## PLANNING REPORT

**JANUARY 21, 2010**

**7. Oakland Nursery  
09-102CDD/CU**

**4261 West Dublin-Granville Road  
Corridor Development District/Conditional Use**

**Plan View with Proposed Arbor and Patio**

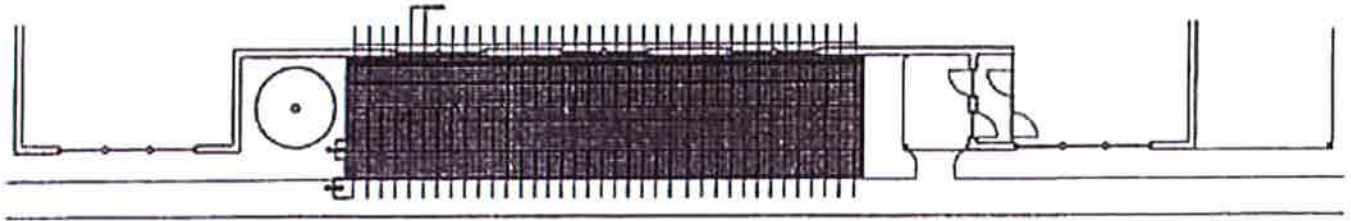
The proposed arbor will cover an area of 500 square feet on the north side of the building and consist of light colored wood. Eight posts hold the arbor in place and the top will have a lattice design. The plans also indicate an option for a “patio” beneath the arbor, where approximately 500 square feet of lawn will be covered with paver stones. The applicant has stated that this area is intended as a seating area but will also display plant material, and therefore Planning recommends that the “patio” label be eliminated since its primary purpose would be for plant display. Since paver materials have not been selected at this time, Planning recommends that the paver design and color complement the building and the arbor.

**Criteria met with conditions:** The new arbor structure adds an element of interest to the existing building and the proposed materials will maintain Dublin's image as a quality community. No details have been provided regarding the pavers, and therefore Planning recommends that the paver design and color complement the building subject to approval by Planning (Condition #4). Planning also recommends that the plans be revised to remove the "patio" label from the proposed paver area beneath the arbor (Condition #5).

- 1) That the display area proposed for the parking lot be reduced to exclude the ten parking spaces located closest to the Dublin Granville Road;
- 2) That the display area proposed for the parking lot be limited to seasonal operation from March through June and September through December;
- 3) That the outdoor display area located within the parking lot be sectioned off with wood barriers or an equivalent, subject to approval by Planning;
- 4) That the paver design and color complement the building and arbor, subject to approval by Planning;

- 5) That the plans be revised to remove the “patio” label; and
- 6) That a stormwater management plan for the paver area that complies with the Stormwater Code is submitted as part of the application for a Certificate of Zoning Plan Approval should the paver area not be reduced to less than 500 square feet.
